Higher Ground Academy

New Secondary School

# Memorandum

To: **Tia Anderson**  
 From: **Dan Grothe**  
 Project: **Higher Ground Academy**  
 Project Number: **16-0117**  
 Subject: **Updated Site Plan Review**  
 Date: **March 12, 2018**  
 Copy To:

**L101**

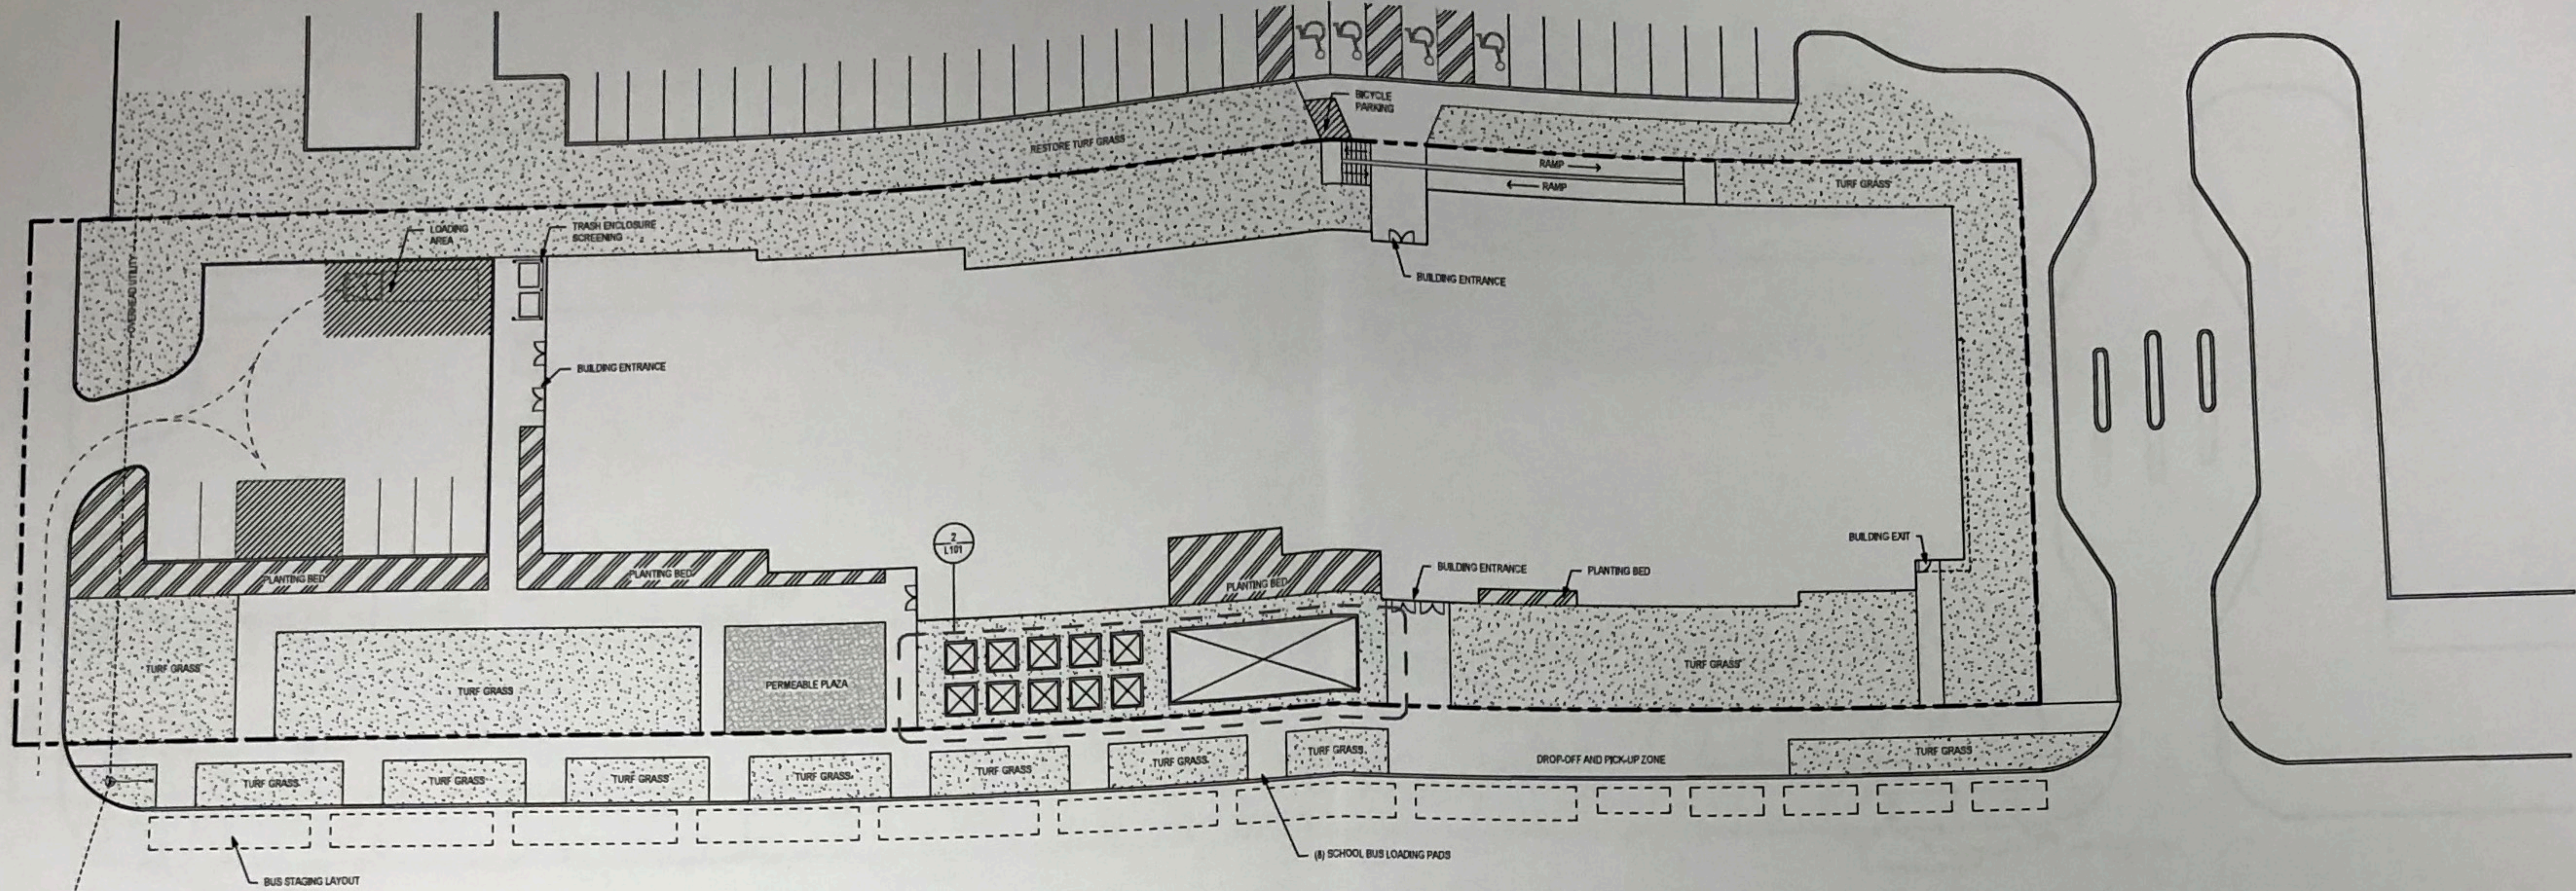
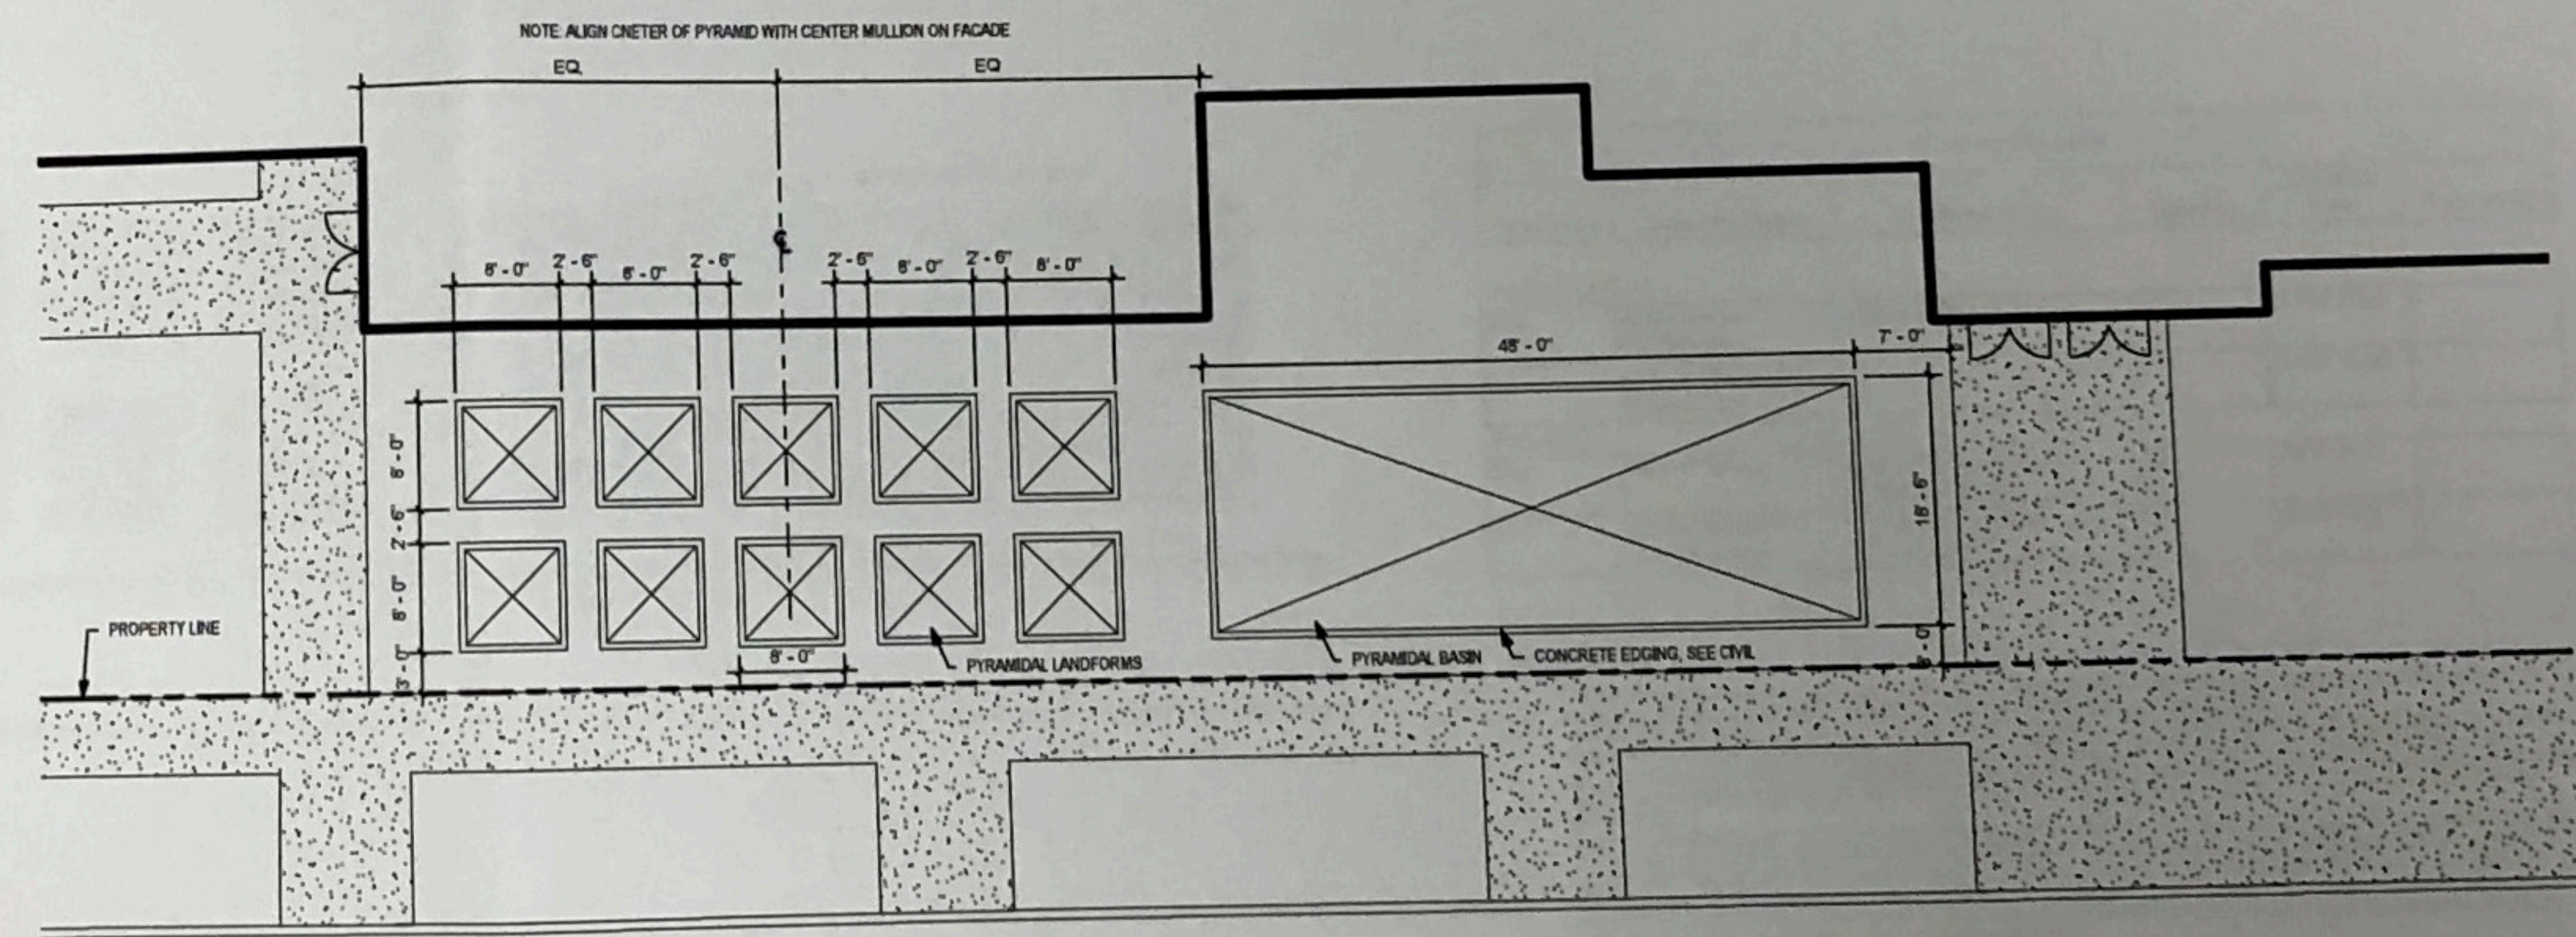
2k	ADA parking identified on L101
2l	Loading dock has been revised. See sheet L101
2m	Screening identified on sheet L101
2n	See updated Landscape and Civil documents
2o	See sheet L101
2q	See drawing 2/A300 for identification of front door and C4.0 for connection to street. Window and door percentage on south elevation is 33.8%.
2r	Exterior lighting will comply with all required ordnances.
3b	See item 2e.
4	Signage permit will be applied for in the future.
5a	Note added to demolition drawing sheet C1.0
6	No action required
7	No action required
8	Identified exception will be provided.
9	No action required
10a	Appropriate permits will be applied for.
10b	Signed drawings will be submitted for permit.
10c	See sheet C4.0
10d	See sheet C4.0
10e	See sheet C1.0
10f	Will be addressed with City and with adjacent property owner.
10g	See item 10f

**4 Landform Detail**  
L300  
1 1/2" = 1'-0"

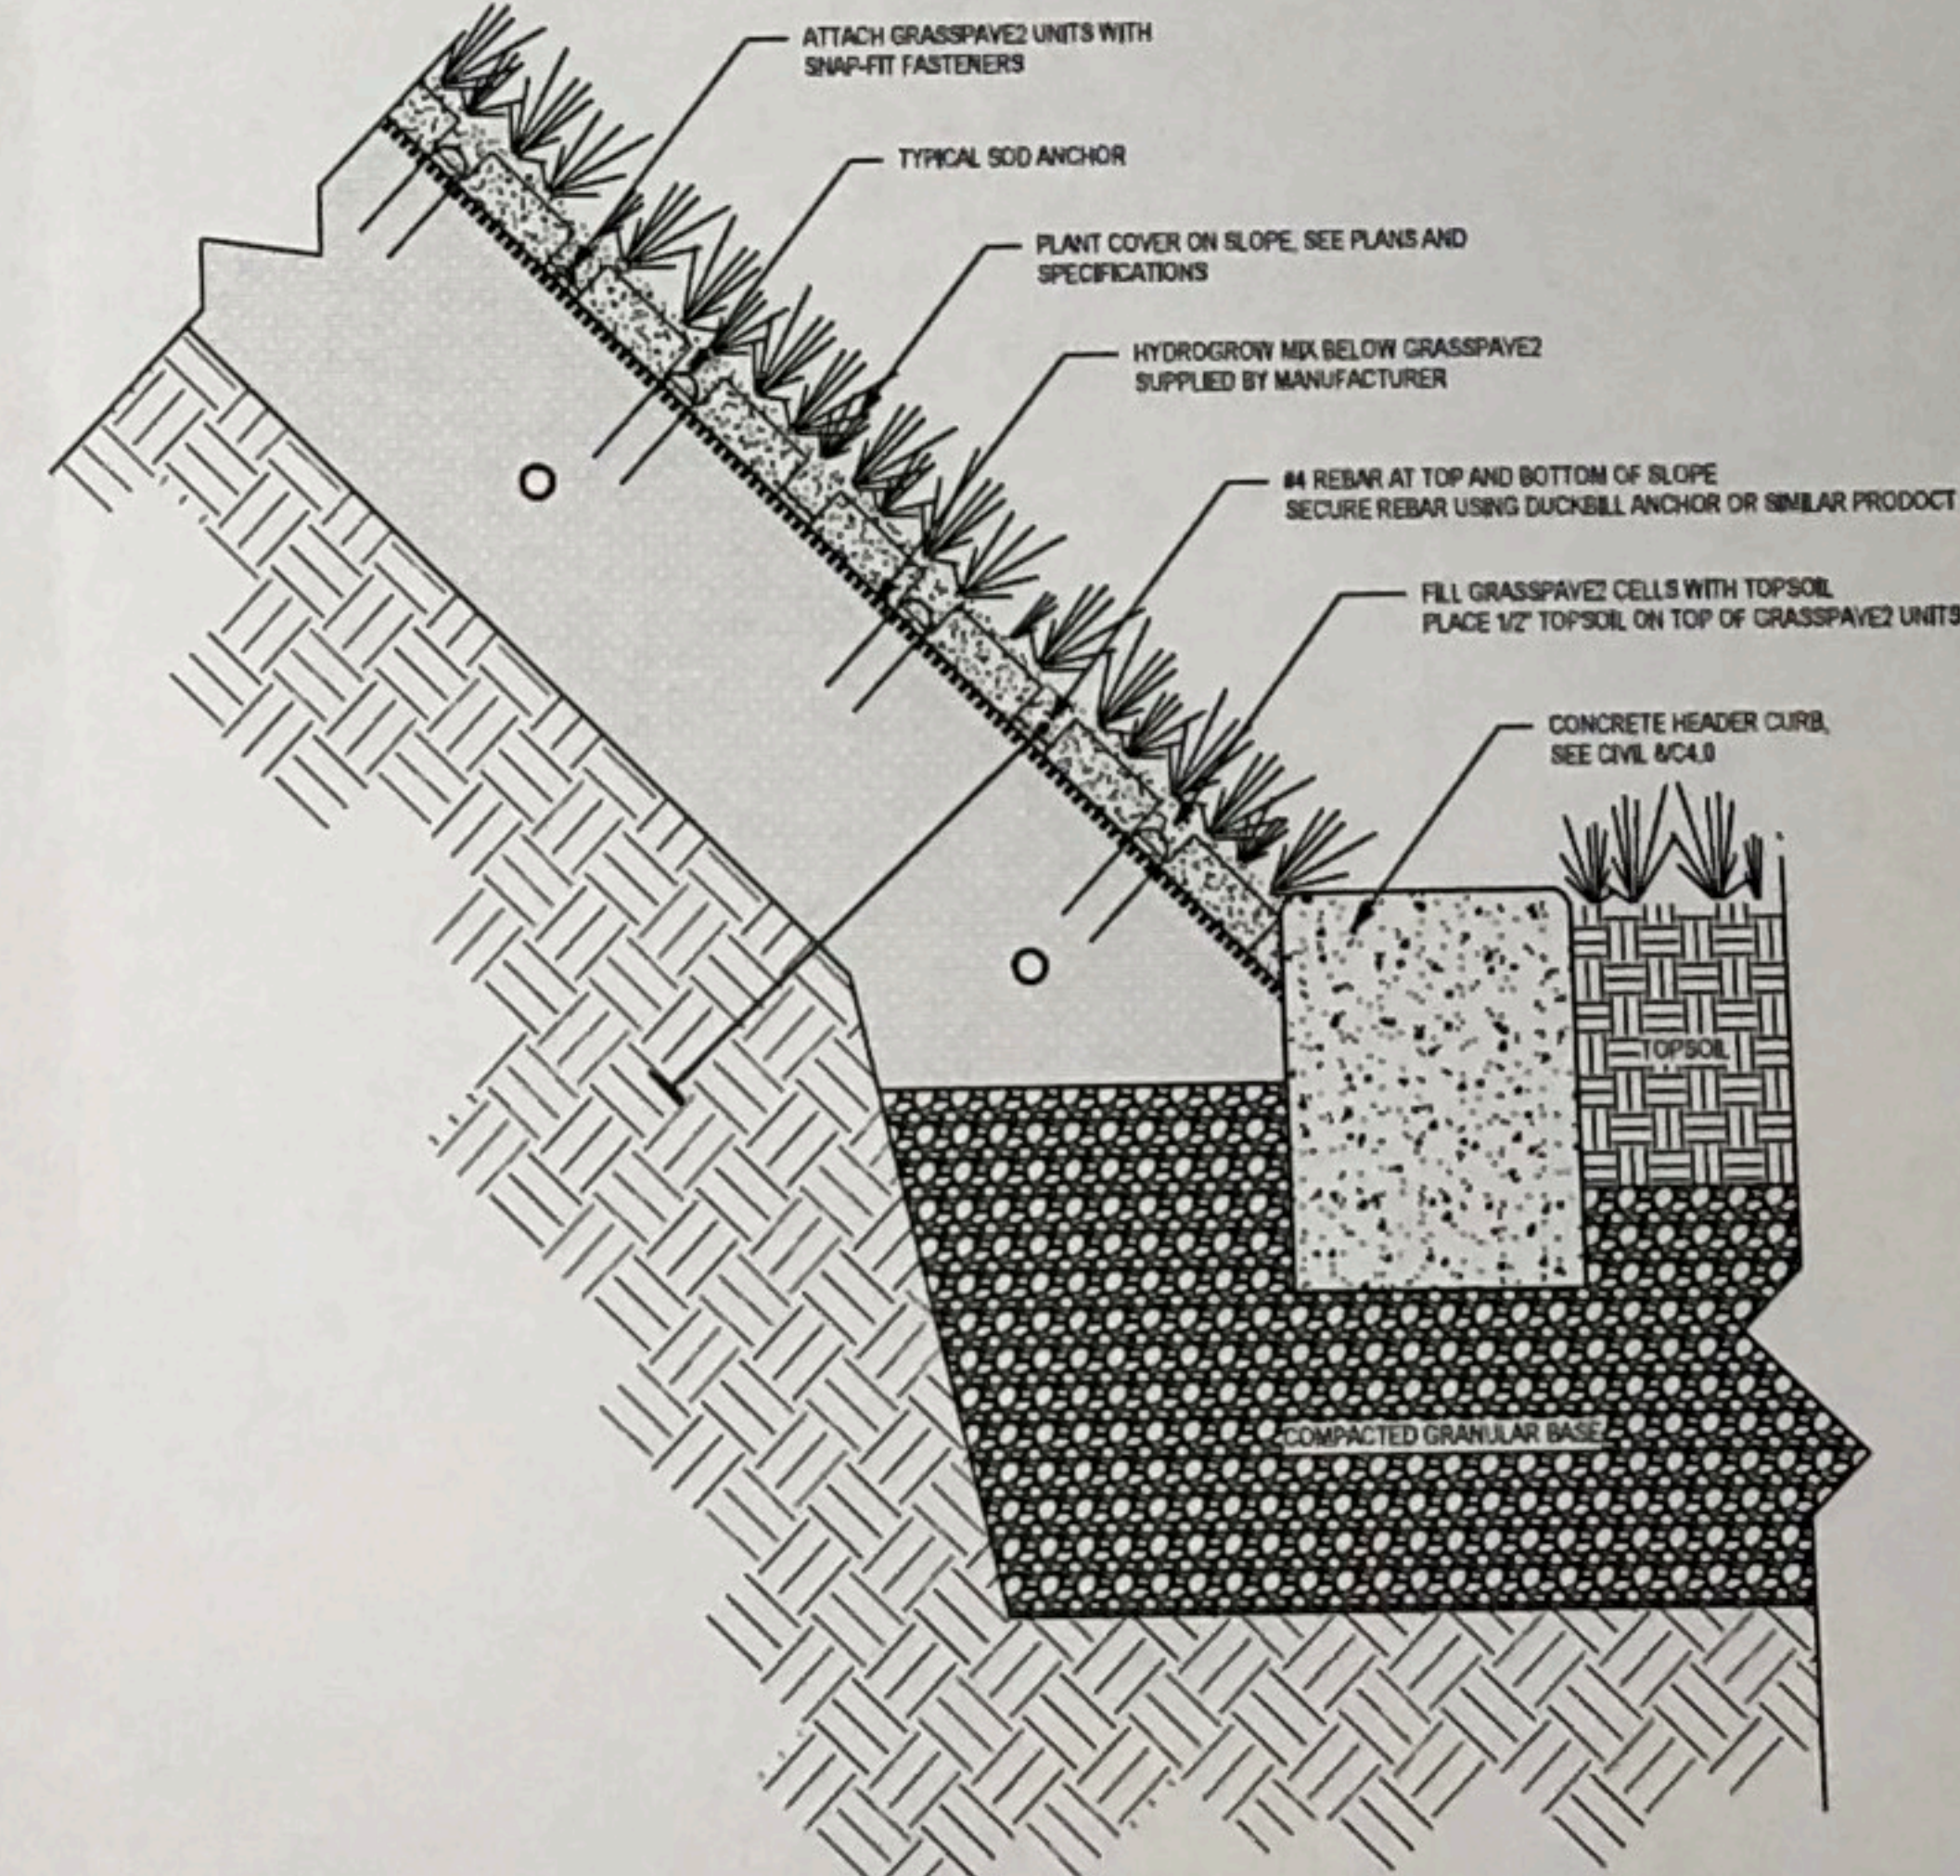
10h	See detail 4/L300.
10i	Requested revisions to ST. PAUL'S NOTES have been made.
11a	See L200 and C4.0
11b	No action required at this time.
11c	See C4.0.
11d	See ST. PAUL'S NOTES 5 and 6.
12	No action required
13a	No action required
13b	See C3.0
13c	See C3.0
14	No action required
15a	See C3.0
15c	See 2/C3.1
15d-e	No action required at this time
15f-j	Requested drawings will be submitted with permit application.
15k	See ST. PAUL'S NOTES 21-24
16a	Fire Department Connection visibility will be maintained.
16b	Required identifying signage will be provided.
16c	Sprinkler system will be provided.
16d	HGA to coordinate north side access with SPC.
16e	See C1.0
17a	See L200 for planting layout.
17b	See L200
17e	See L200
18	No action required
19	MPCA permit will be obtained.
20a	Capitol Region Watershed permit was applied for on 2.28.18.
21	All referenced codes and ordinances will be met.
22	All required building permits will be applied for prior to the start of construction.
